Date: 15 December 2023
Contact: Craig Morse
Location: City Development
Telephone: (07) 5582 8926
Your reference:
Our reference: OPW/2023/1350

Information Request

in relation to development of land/premises described as:
Lot 191 RP173728, Lot 192 RP173728 – 97 Courtney Drive, Upper Coomera Qld 4209

Figure 1: bulk earthworks plans showing contours and water flow for Park Lot 1007 as well as landscape treatment for drainage swale.

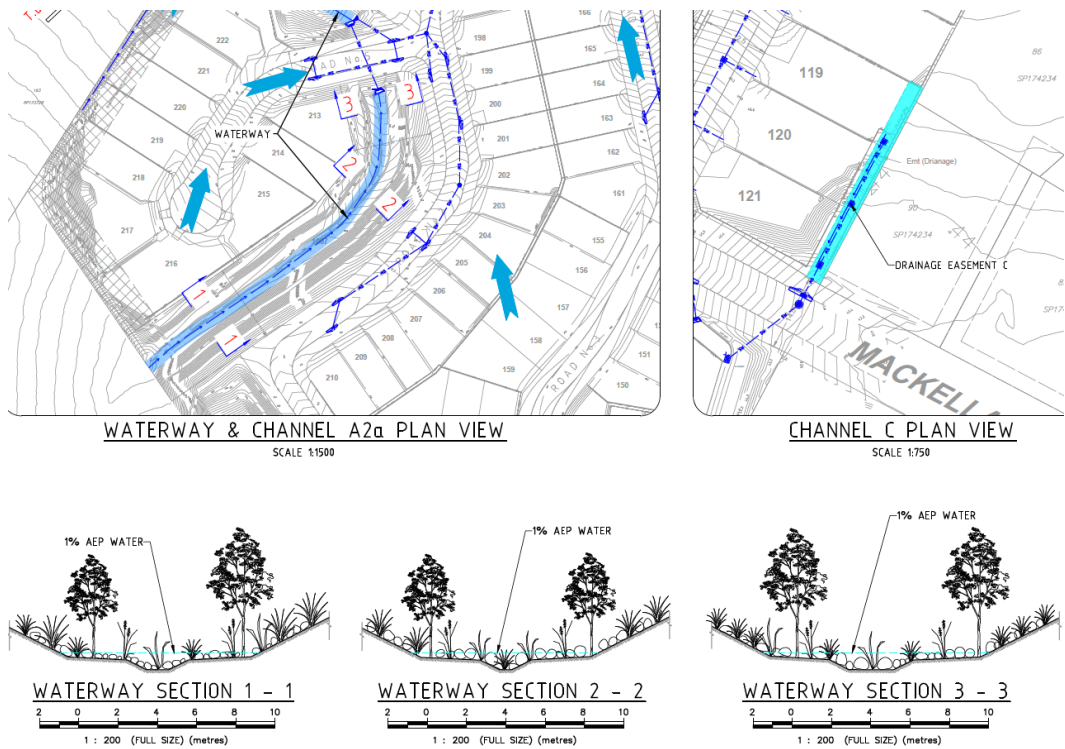
- c The current OPW plans do not provide an indication that this will be achieved rather a straight rock lined channel with uniform depth and 1:2 batters.

- d The applicant is requested to demonstrate that the final design will achieve a reconstructed natural waterway which will also support the planting of a number of plant strata including larger canopy trees (Melaleuca and Casuarina) as well as shrub and understory species in accordance with the proposed hydraulic function such as nil impedance of the low flow channel.
